Access Compliance Report

Public Rights-of-Way

Intersection ID: 47579	Main Street: EVANTON_LOCH_RD	Cross Street: BARRANDS_LN	Location: SW
ADA ID: B163FB7DC1AB	Ramp Type: PerpDiag	Initial Pass/Fail: Fail	Overall Compliance: No
Severity Score: 12.5			
Codes/Mitigation Info/Possible Solution		Field Measurements/Component Compliance

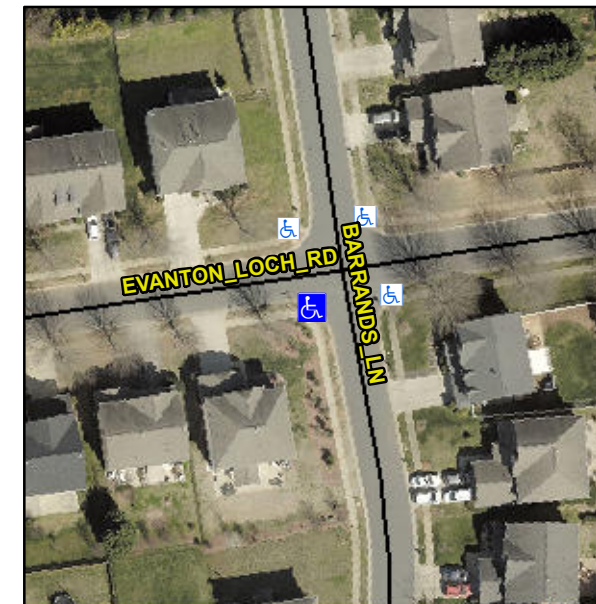
Remove & Replace Curb Ramp With Two New Directional Ramps or Equivalent.

R304.2.2

Compliance	Description	Data	Compliance	Description	Data
N/A	Ramp Length (in)	48.0	No	Ramp Slope (%)	8.5
Yes	Ramp Width (in)	48.0	Yes	Ramp XSlope (%)	1.0
N/A	Flare Type LT	N/A	N/A	Flare Type RT	N/A
N/A	Flare Slope LT (%)	N/A	N/A	Flare Slope RT (%)	N/A
N/A	Flare Traversable LT?	N/A	N/A	Flare Traversable RT?	N/A
N/A	Landing Length (in)	N/A	N/A	DWS Provided?	N/A
N/A	Landing Width (in)	N/A	N/A	DWS Contrast?	N/A
N/A	Landing Slope (%)	N/A	N/A	DWS Length (in)	N/A
N/A	Landing X Slope (%)	N/A	N/A	DWS Full Width?	N/A
N/A	Landing Curb? (Y/N)	N/A	N/A	DWS Offset (in)	N/A
N/A	Shared Landing?	N/A			
N/A	Gutter Ponding?	N/A	N/A	Gutter Slope (%)	N/A
N/A	Gutter Lip Ht (in)	N/A	N/A	Gutter X Slope (%)	N/A
N/A	Painted X Walk1?	No	N/A	Painted X Walk2?	No
	X Walk 1 Direction	To E		X Walk 2 Direction	To N
N/A	X Walk 1 Width (in)	N/A	N/A	X Walk 2 Width (in)	N/A
	X Walk 1 Slope (%)	3.6		X Walk 2 Slope (%)	1.8
	X Walk 1 X Slope (%)	1.4		X Walk 2 X Slope (%)	0.5
